Burlington Development Review Board

Development Review Board

ZP-25-310; 633 Main Street (I, Ward 1) University of Vermont / State Agricultural College / Claire Forbes

Proposed conversion of existing fenced area into an outdoor lab with associated site improvements. (Project Manager, Mary O'Neil)

C-1.0

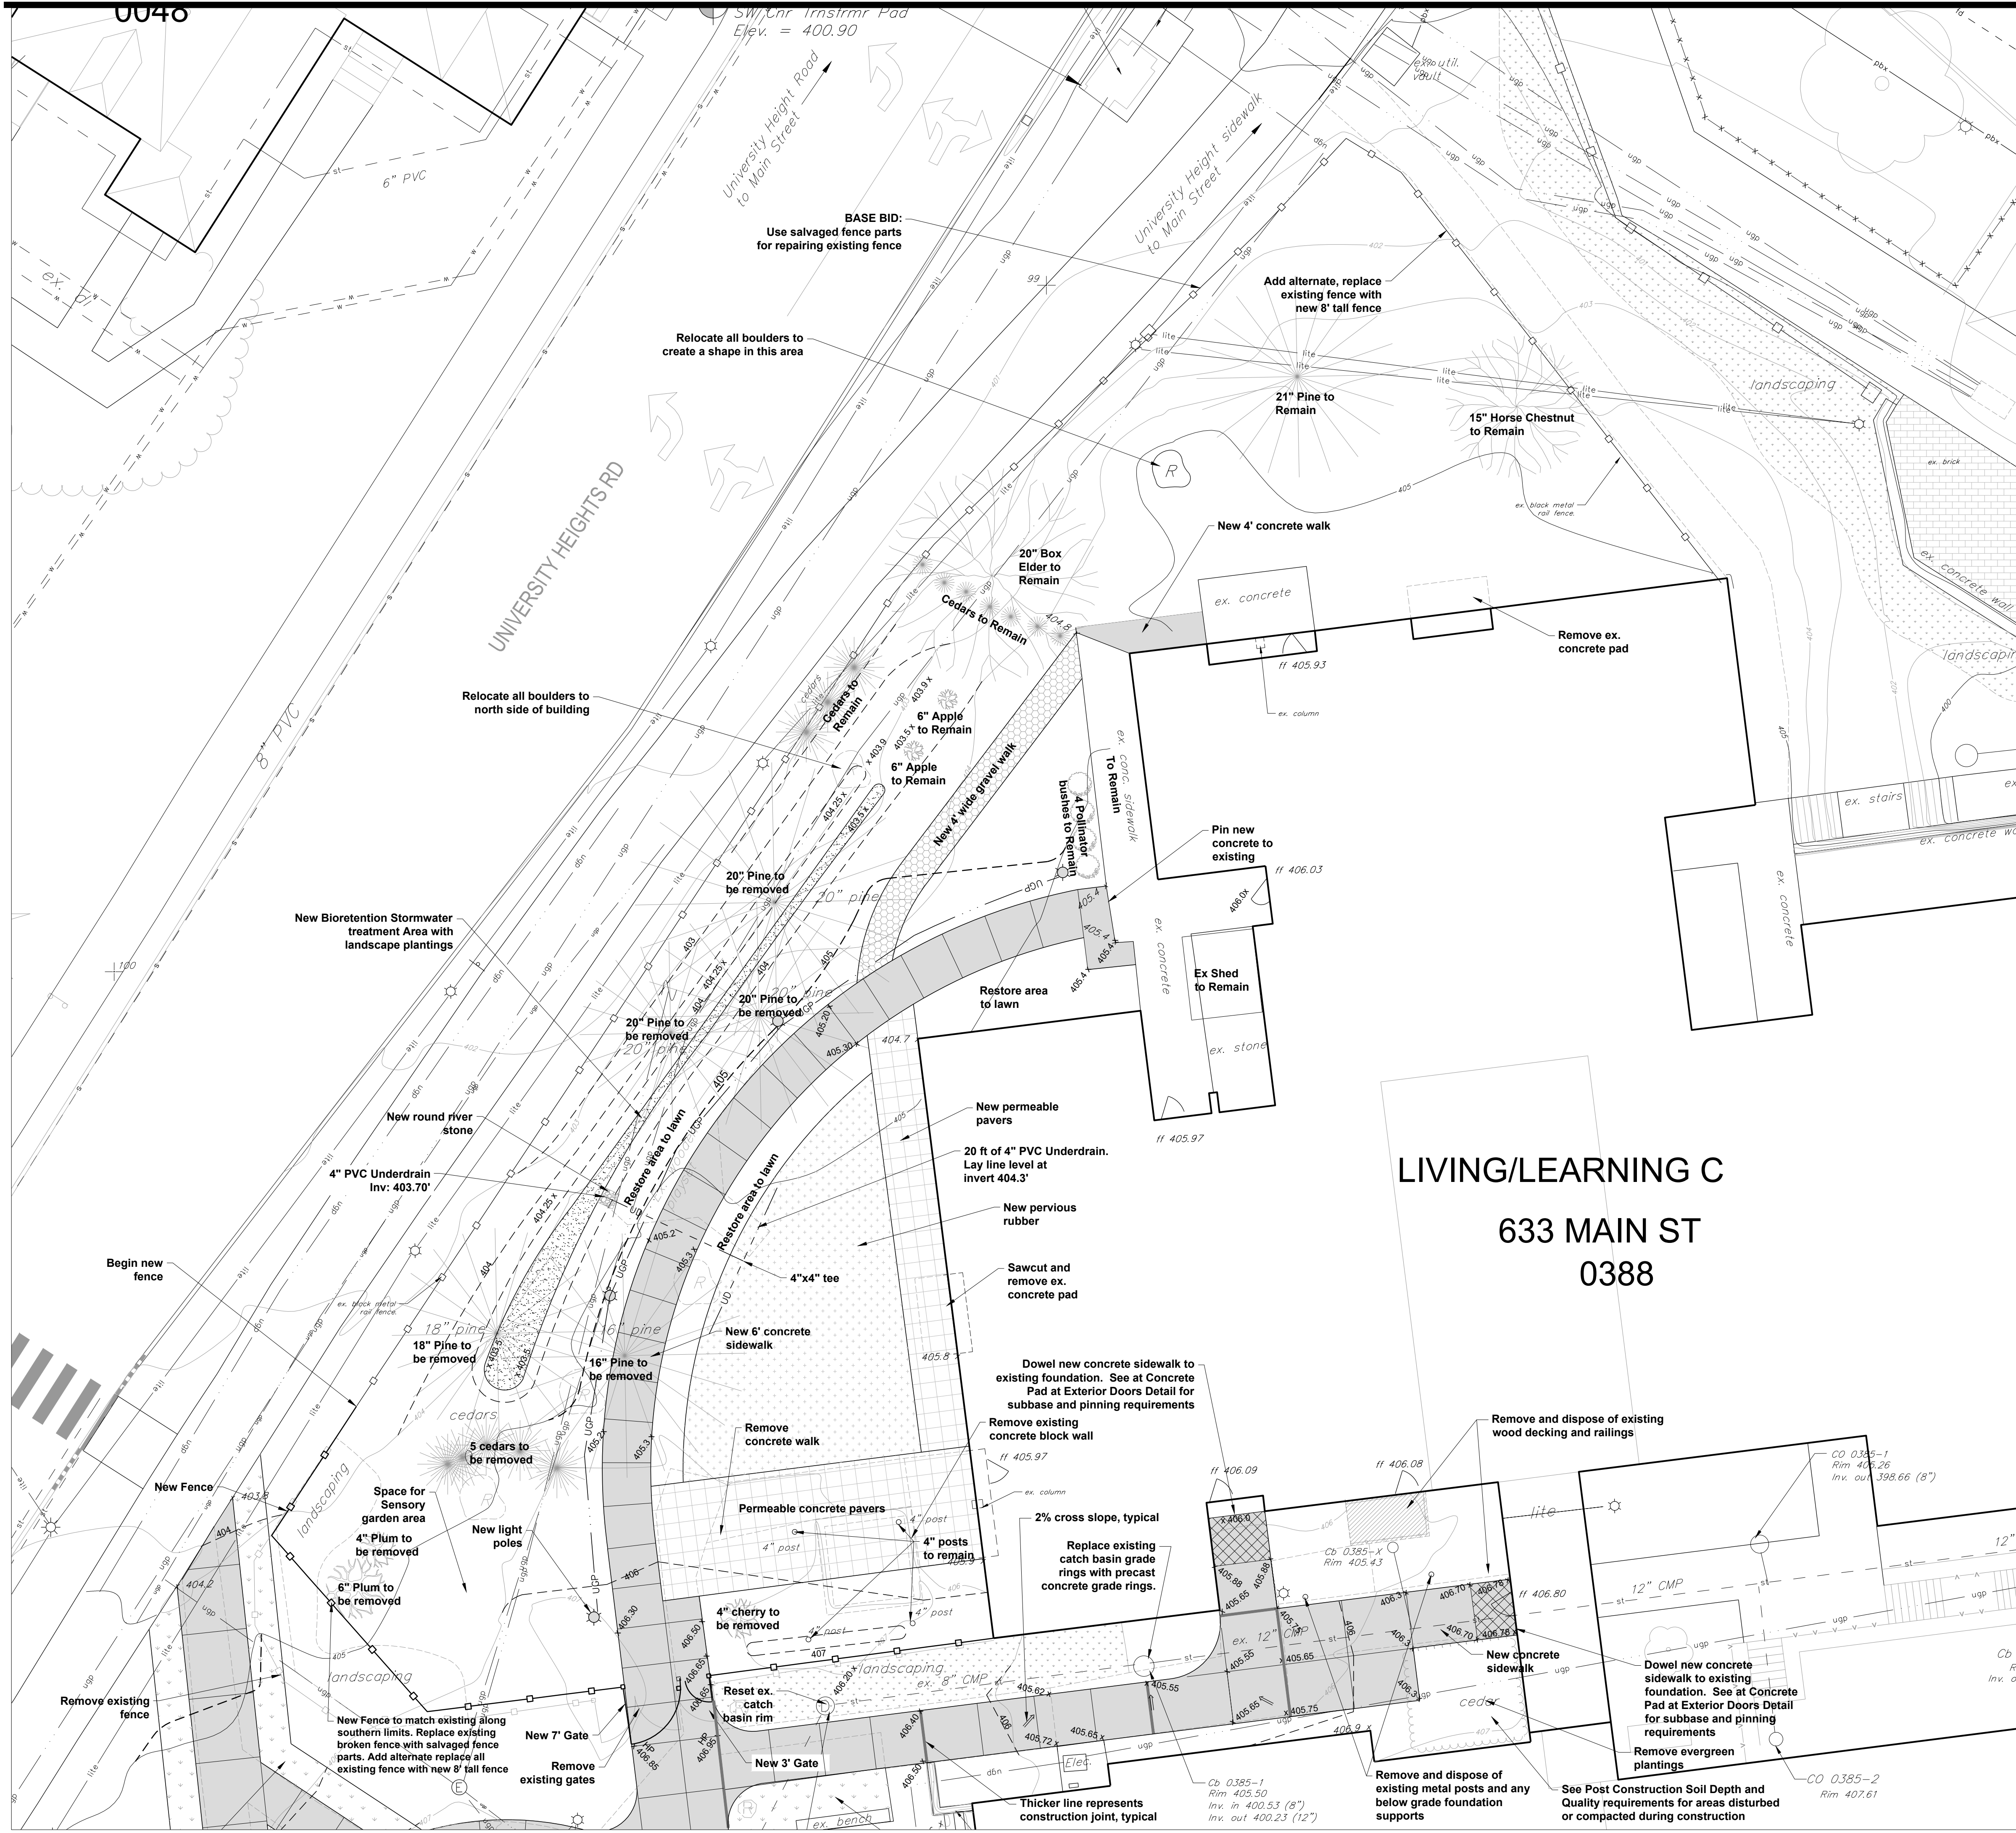
No new surface parking is proposed; in fact there will be a net decrease of 1 space to provide 2 newly marked handicap accessible spaces. Reference is made to plan C-1.0.

The project is a highly designed re-visioning of this corner, creating a highly-functioning, interconnected stream of use that enhances pedestrian circulation, stormwater attenuation, mobility (bike parking and ADA parking access), and utility and landscape improvements. Reference is made to Plans C-1.0 – C-1.3 for specific details.

Reference is made to Plan C-1.0 for their location; adjacent to the access walkway.

E1.1

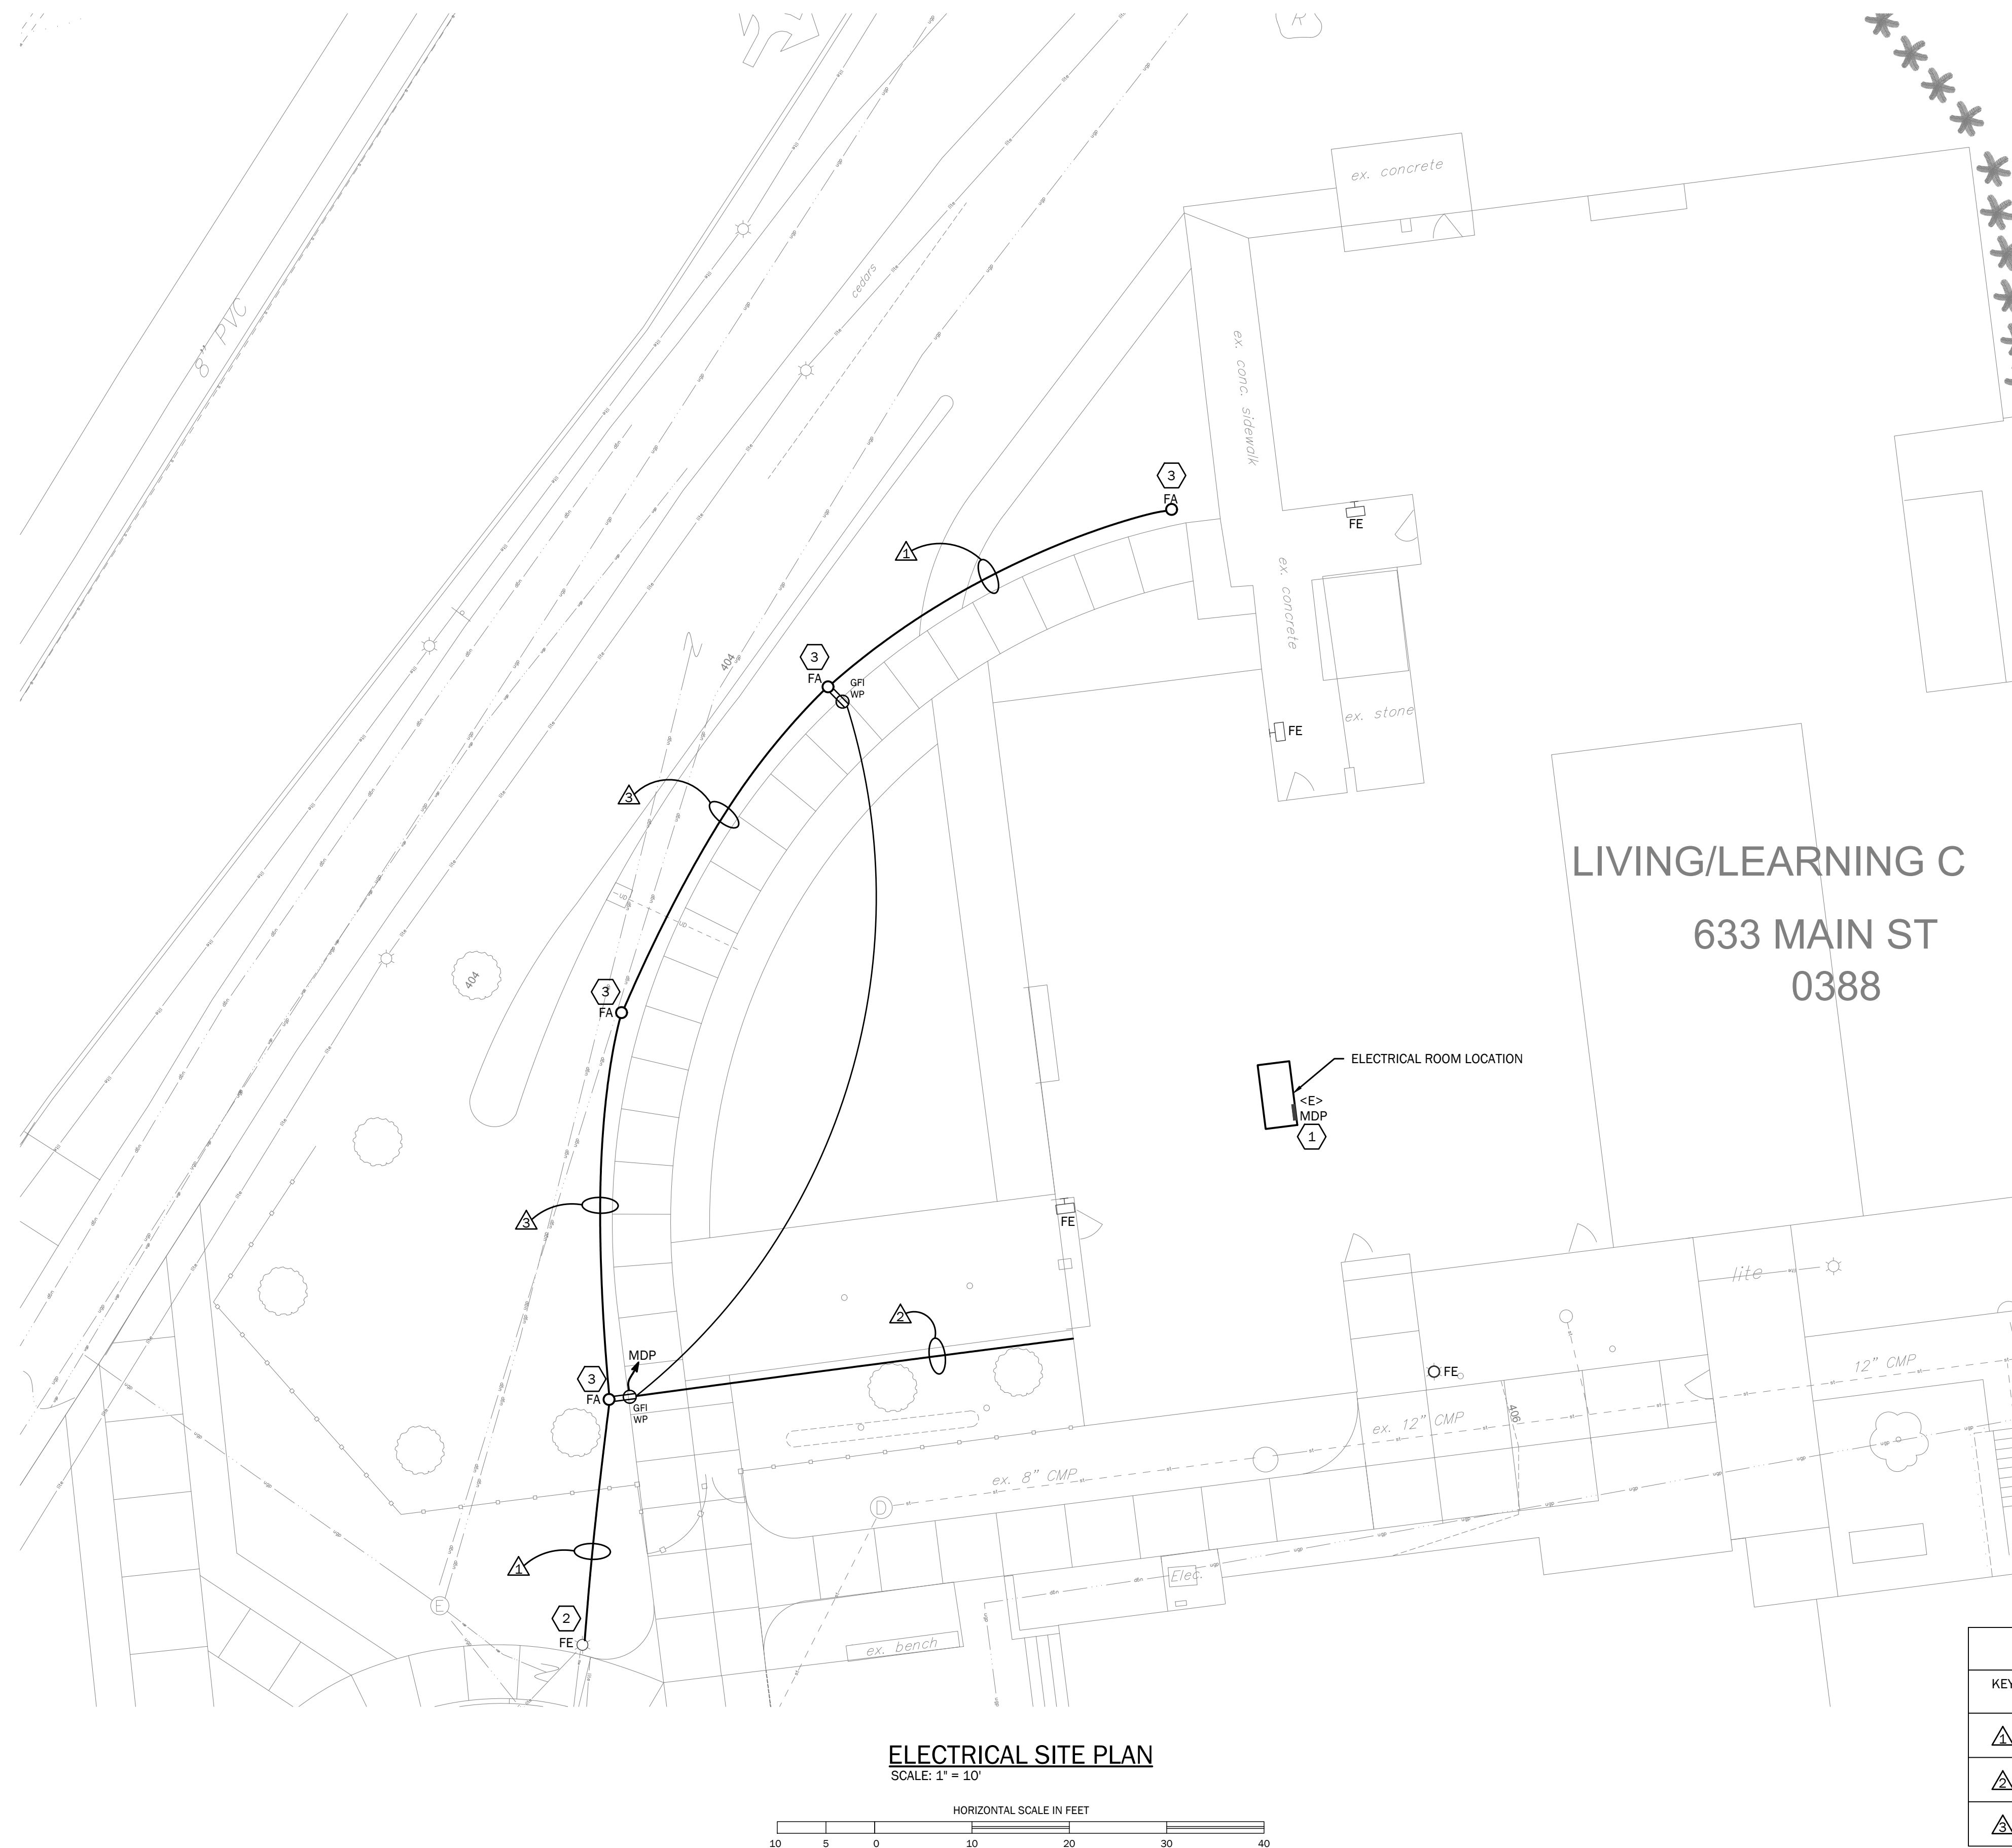
Four LED pole lights atop 10' poles are proposed to be added along the new concrete walkway, joining existing light fixtures. The photometric confirms compliance with illumination maximum standards identified under Section 5.5.2 (f) 2 (Walkway lighting). Reference is made to Plans E-1.1 and E-2.1. **Affirmative finding.**
